10 January 2022

BLM Office Renovations
Pearl Public School District – Pearl, MS

ADDENDUM NO. 01

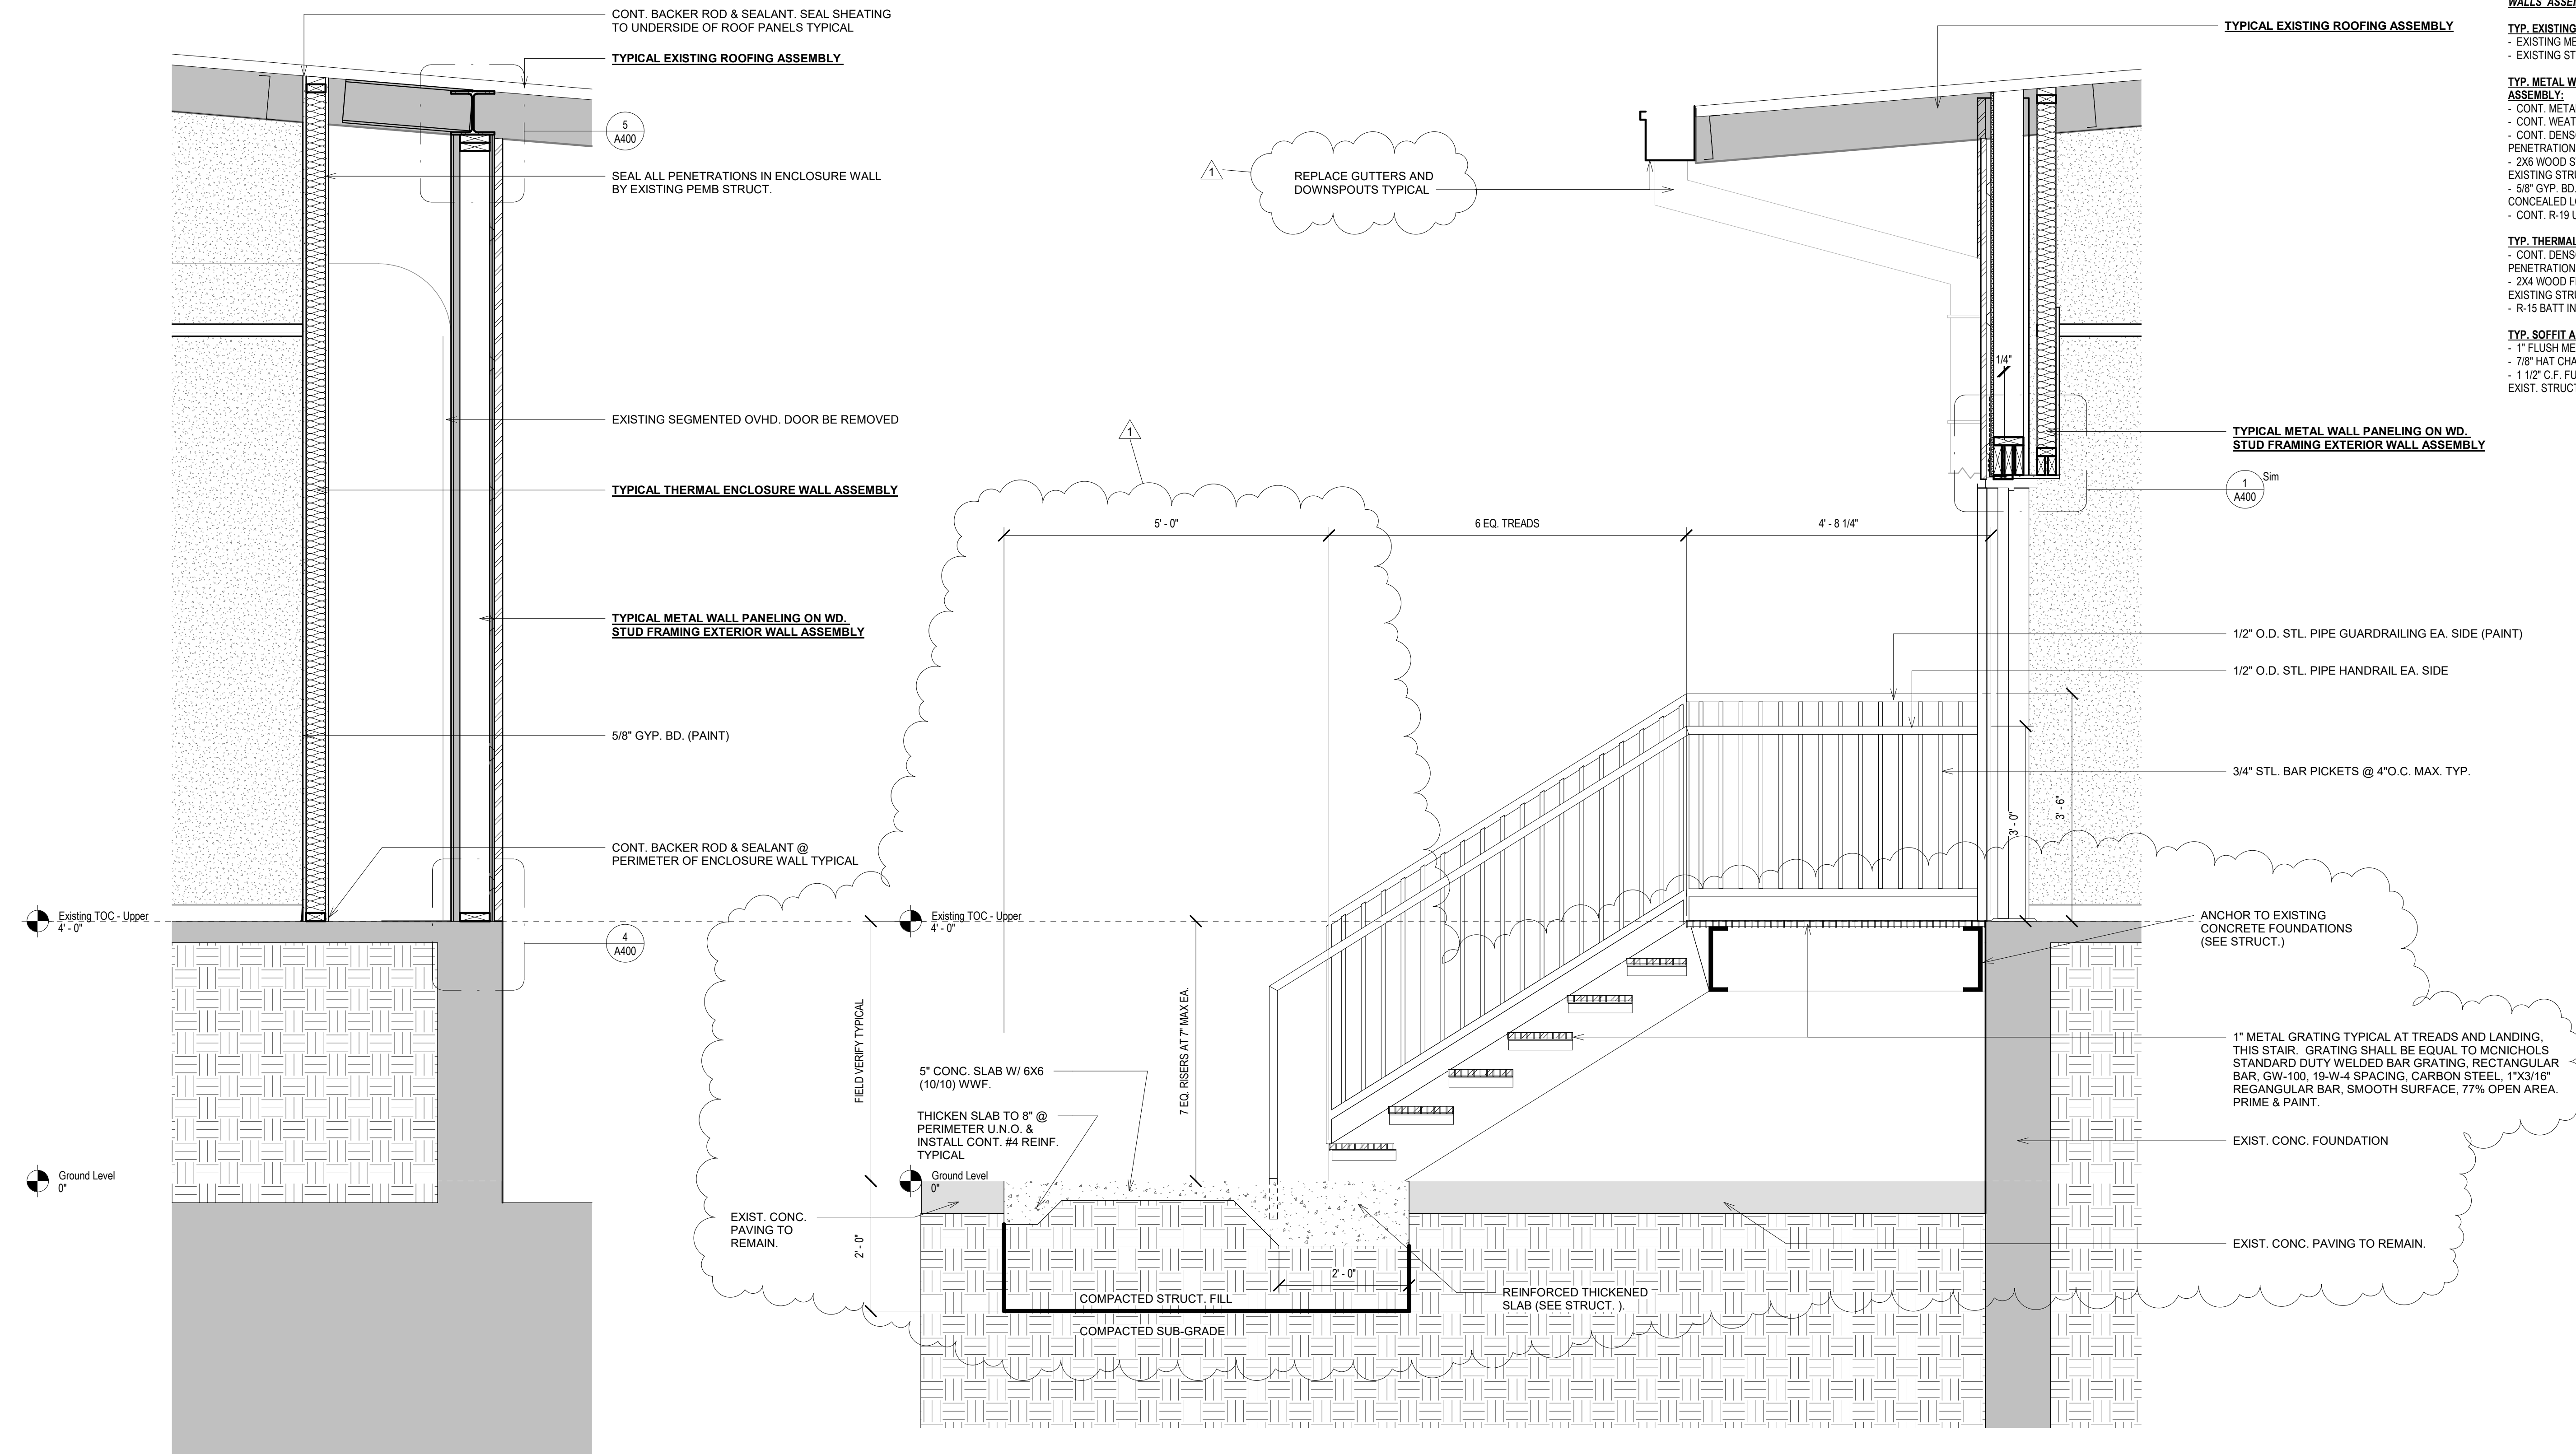
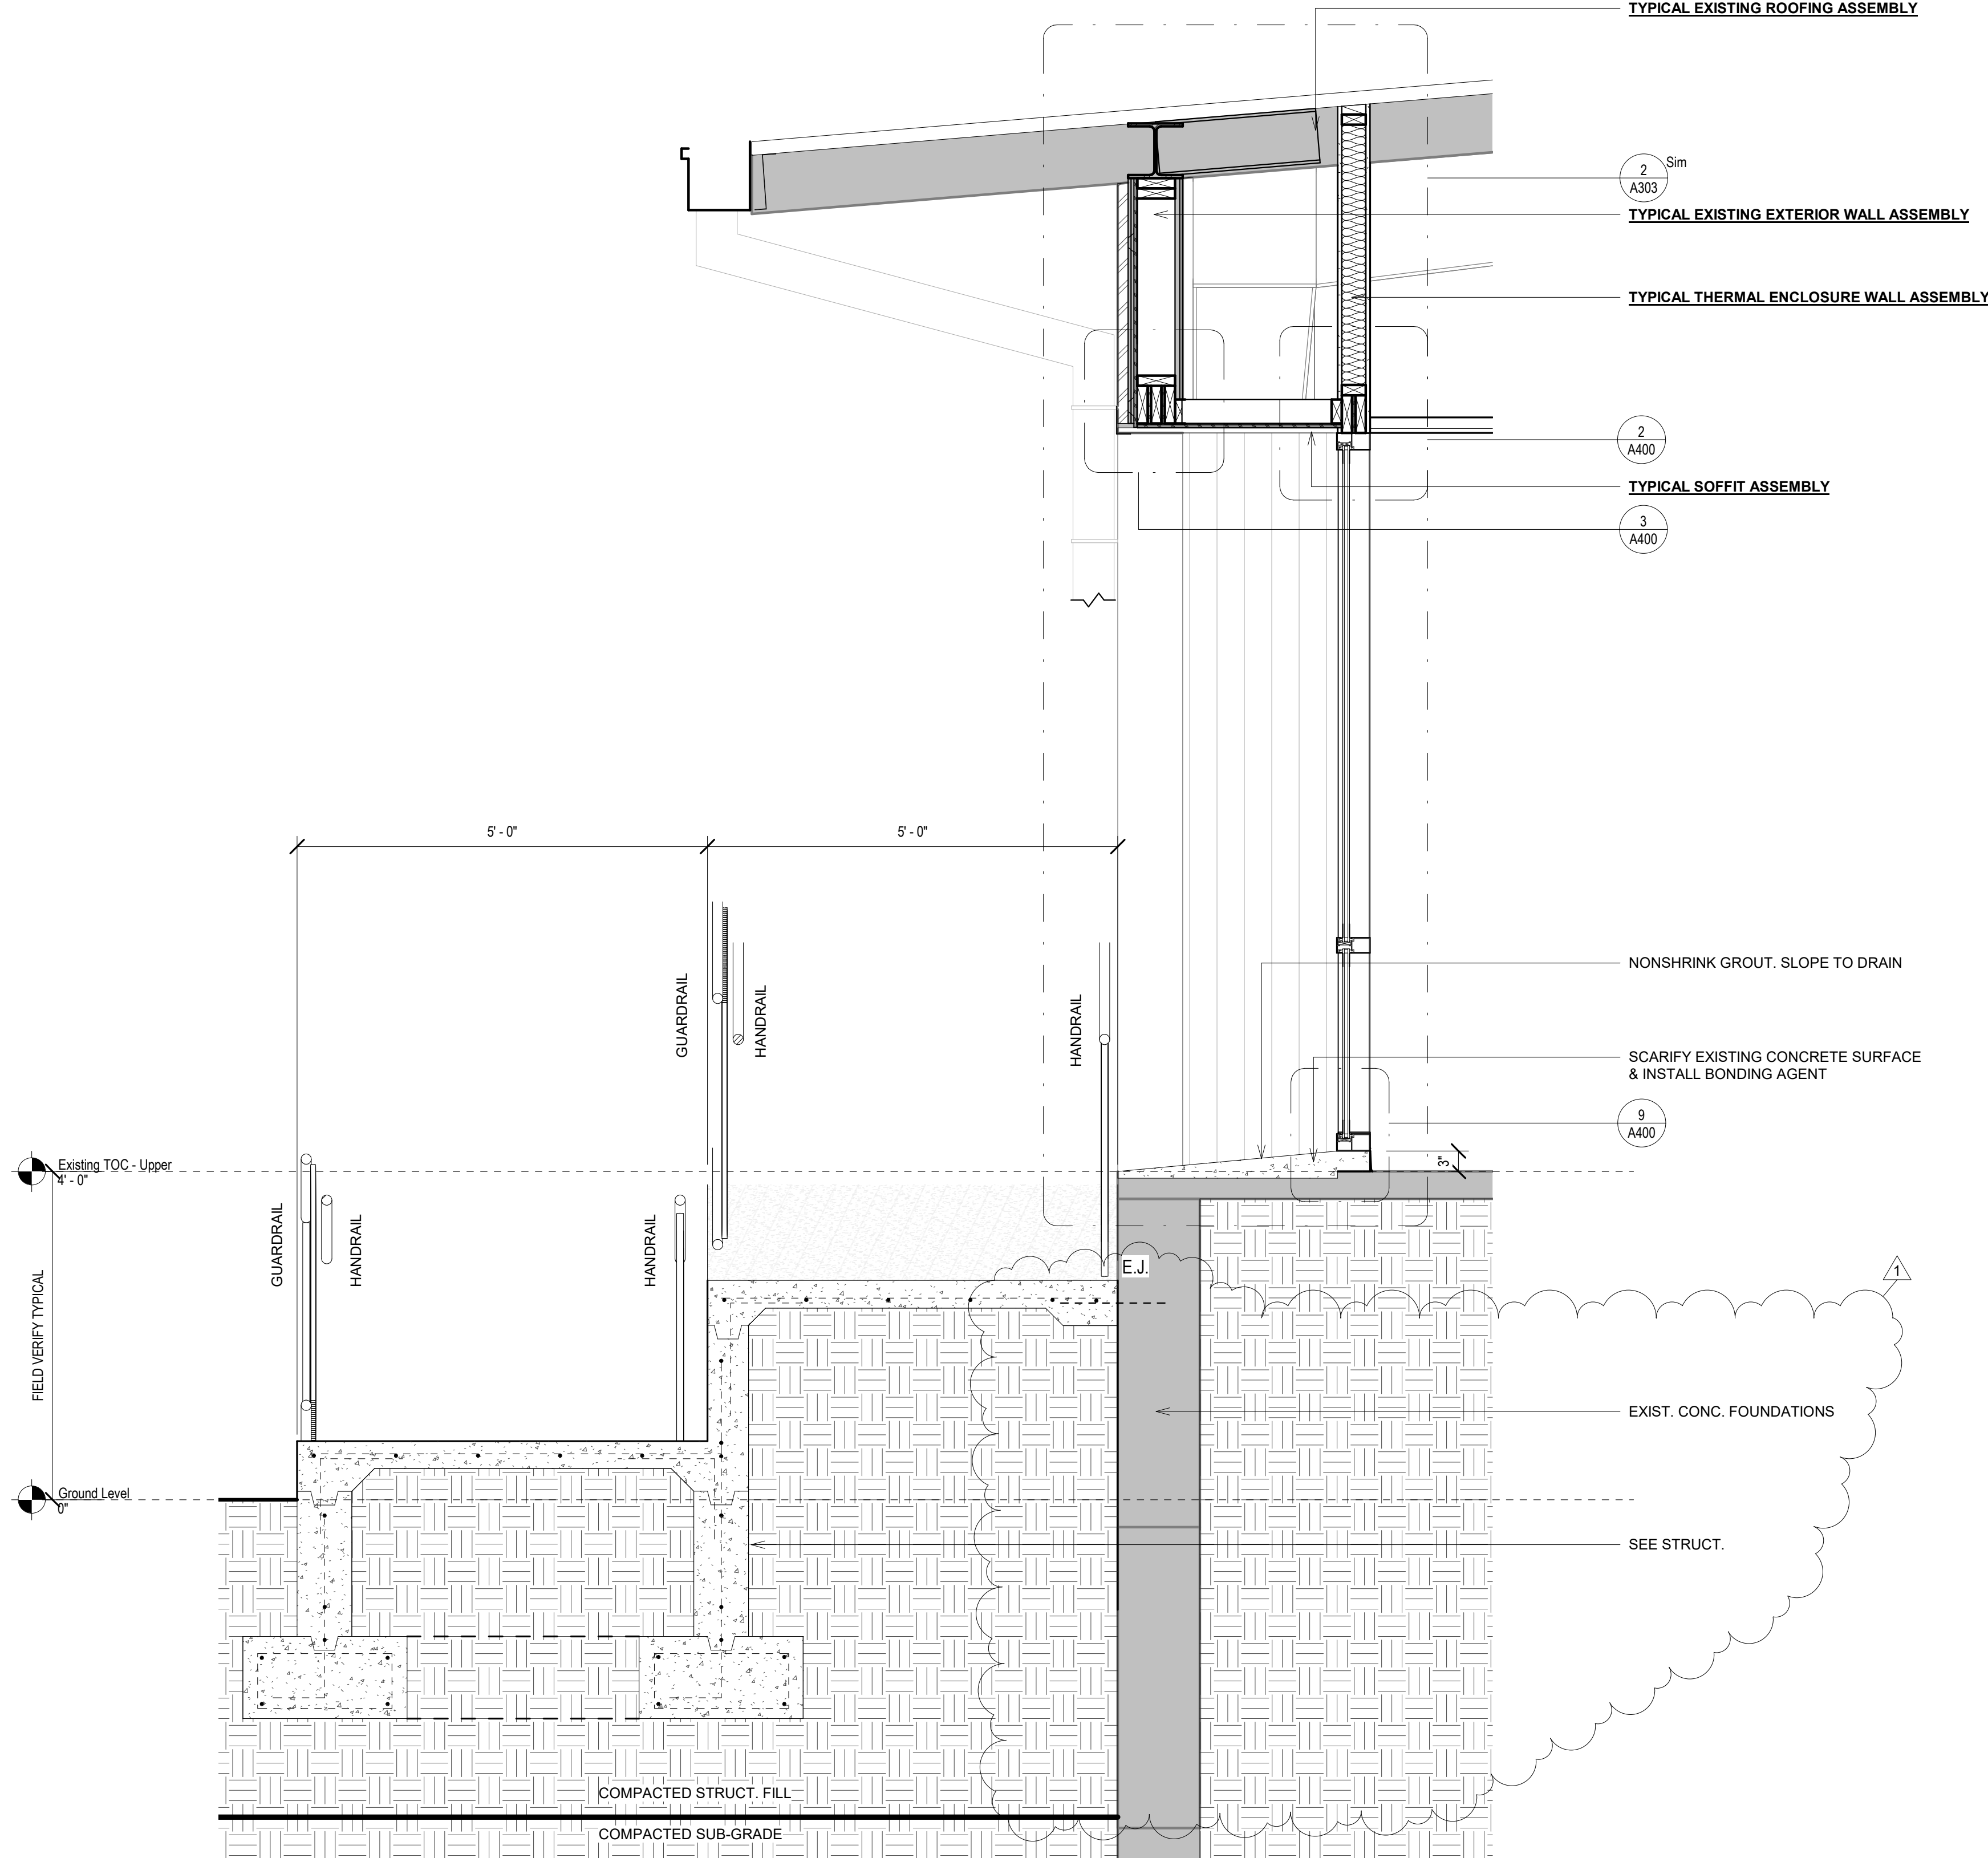
| ITEM NO. 9 | <p>A300 WALL SECTIONS</p> <p>A301 WALL SECTIONS</p> <p>A302 WALL SECTIONS</p> <p>A303 WALL SECTIONS</p> <p>Revise per the enclosed sheets.</p> |
